OBJECTION FROM OLD OAK NEIGHBOURHOOD FORUM TO APPLICATION AT ONE PORTAL WAY 21/0181/OUTOPDC

The Old Oak Neighbourhood Forum wishes to object to this application and asks that it be refused or withdrawn. The Forum was designated by OPDC in 2018 and has a membership of 60 residents living within the neighbourhood boundary and a further 60 affiliate members within Ealing and the northern part of Hammersmith.

CGI image from Pilbrow and Partners as included in the Design and Access Statement for application 21/0181/OUTOPDC c

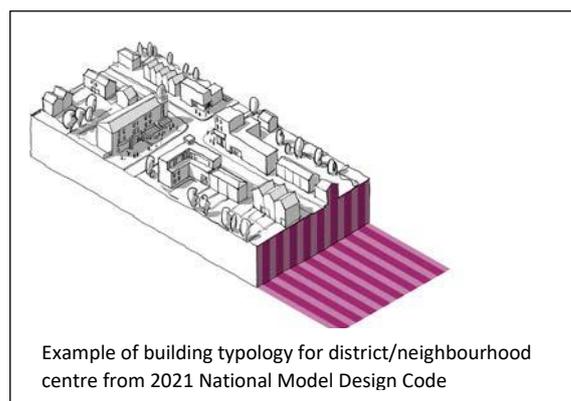
The CGI image below of a North Acton were this application to be built out (along with other consents yet to be constructed) does not lift the hearts of local people. It bears no relation to the building typology for a 'neighbourhood centre' in the national model design code.

But the 'North Acton cluster' is now becoming weighted towards very high density development closer to the A40 rather than around North Acton station (where surrounding towers now look modest as compared to this application). We see no evidence that this application will help in the long term to make North Acton a successful place, with a coherent spatial hierarchy, in the manner expected both by the NPPF and D4 of the London Plan.

Figure 3.15 from Modified Draft OPDC Local Plan. This shows specific locations for tall buildings along Scrubs Lane. But no such locations at North Acton. We consider this contrary to Part B of London Plan Policy D9.

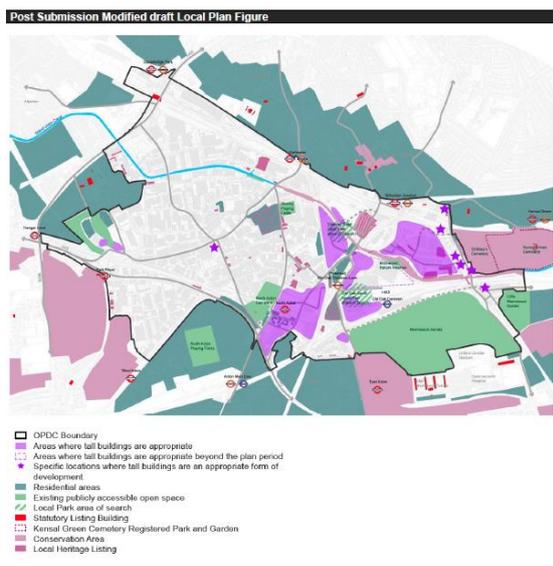
In our view c) above is clearly not met. OPDC modified Figure 3.15 shows an area of approximately 33 hectares at North Acton/Acton Wells deemed to be 'appropriate for tall buildings'². No specific locations for tall buildings are identified on the map. By contrast, locations are shown for tall buildings along Scrubs Lane, within a separate 'Place' as defined in the OPDC Draft Local Plan. As we have argued in our separate submission to the Planning Inspector, an area of the size of 33 hectares cannot be reasonably be considered as a 'location' or 'particular place' in the sense now incorporated in the modified London Plan D9.

Figure 4.71 from OPDC Modified Draft Local Plan

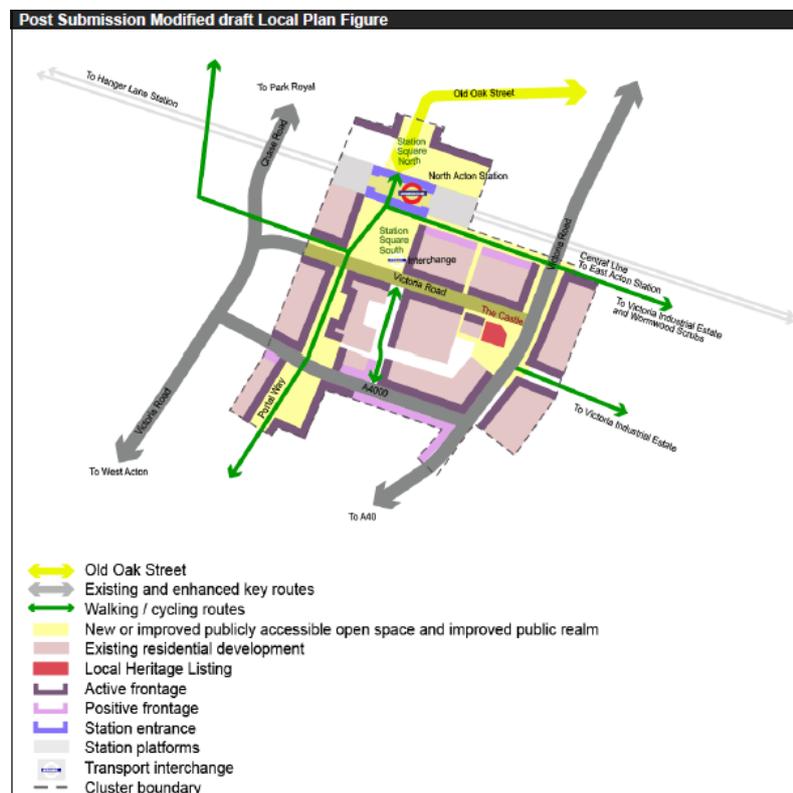
Modified Figure 4.71 in the PSMDLP is a detailed map referring to Policy P7 (see overleaf). Modified Figure 4.73 is a further map referring to Policy PC7C1. Neither map shows suitable or appropriate locations for tall buildings. Nor do they include information on appropriate heights.
